# FINAL MISSION BAY SUBSEQUENT ENVIRONMENTAL IMPACT REPORT

PLANNING DEPARTMENT FILE NO. 96.771E

## VOLUME III: SUMMARY OF COMMENTS AND RESPONSES

**FIGURE J.1 (REVISED) SAN FRANCISCO CLEAN WATER PROGRAM  
COMBINED SEWER SYSTEM CONCEPTUAL DIAGRAM**

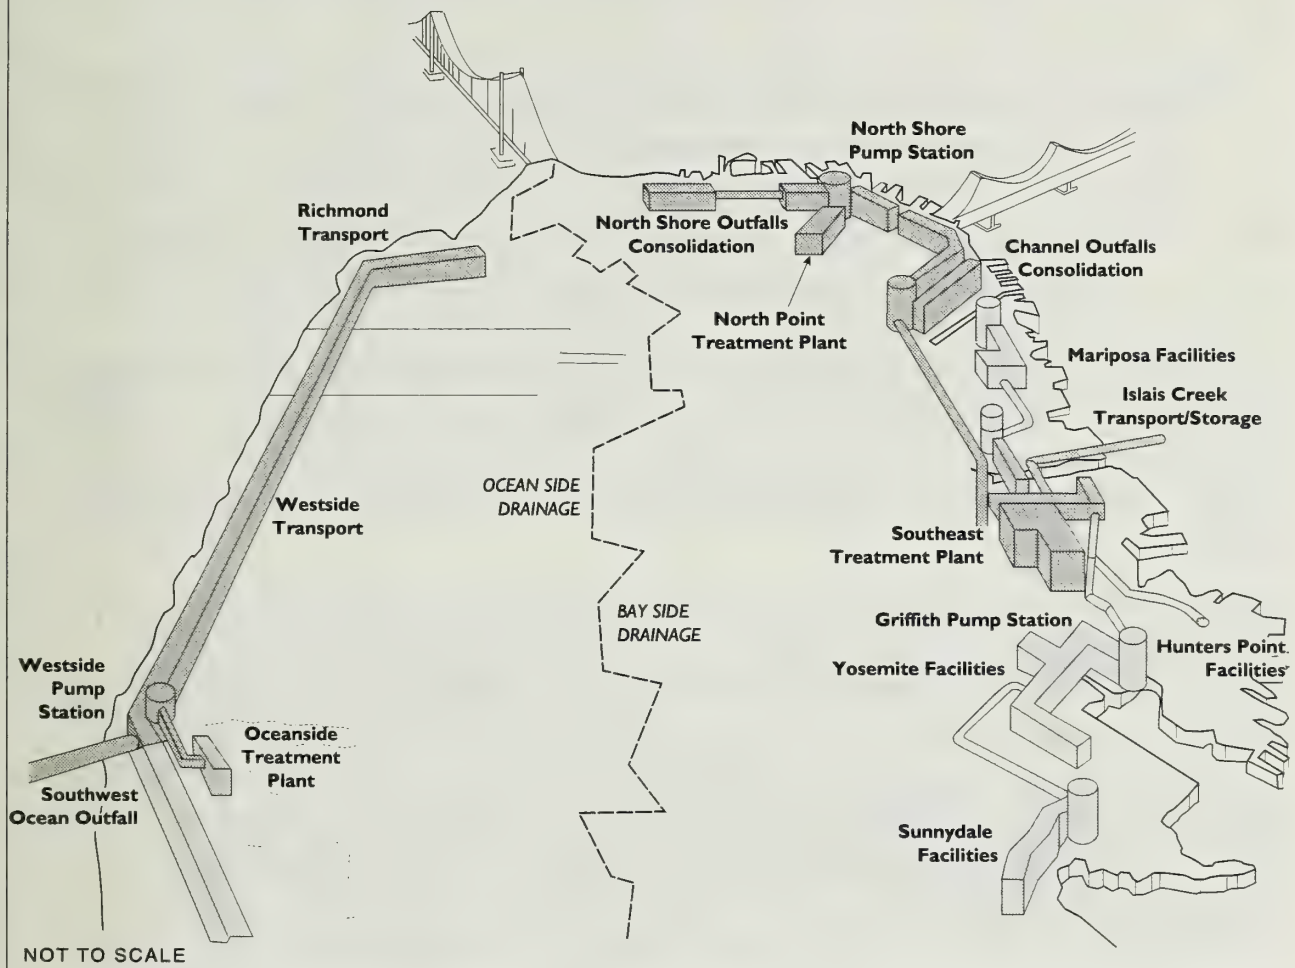
[T]here seems to be an oversight in Figure J.1, of Volume III. The map of San Francisco, which illustrates the Cities' waste treatment system shows a "Cross Town Tunnel (not yet scheduled for construction)." The Board of Supervisors has stated in a resolution last year that this is no longer a feasible solution to expanding the system and that the city will not be considering this option in the future. Therefore, it should be removed from the figure and any reference to it omitted. (*Michael J. Paquet, Environmental Committee Chair, Surfrider Foundation, San Francisco Chapter*)

And first I'd like to also state the oversight of the cross-town tunnel being in the report in Figure J-1, very back end of the third volume.

These comments recommend revising Figure J.1 on p. J.2 of Appendix J, Hydrology and Water Quality, to eliminate the reference to a cross-town tunnel. The *San Francisco Wastewater Master Plan* includes a cross-town tunnel to transport wastewater from the Bayside to the oceanside. In 1974, when the Wastewater Master Plan was adopted, wastewater discharge standards were changing rapidly, and the City believed future restrictions on wastewater discharges to the Bay could necessitate this major capital project. However, the Regional Water Quality Control Board never required the construction of the tunnel as a National Pollutant Discharge Elimination System (NPDES) permit requirement, and San Francisco now complies with its NPDES permit requirements. See also the responses regarding “Background Regarding the Existing Combined Sewer System” on pp. XII.232-XII.238 and “Wet-Weather NPDES Permit” on pp. XII.371-XII.376. The San Francisco Board of Supervisors has not adopted formal legislation to remove the cross-town tunnel from the Wastewater Master Plan, but the tunnel is no longer considered a foreseeable option for future wastewater management./27/ As discussed in the response regarding “New Water Quality Standards” on p. XII.371, future changes to discharge standards cannot be anticipated; however, if new standards are ever promulgated that substantially affect the City’s ability to discharge wastewater to the Bay, the City would likely study reasonable options and alternatives to achieve the new discharge requirements at that time. Because the cross-town tunnel is no longer reasonably foreseeable, Figure J.1 has been revised as shown on the next page to remove the reference to it.
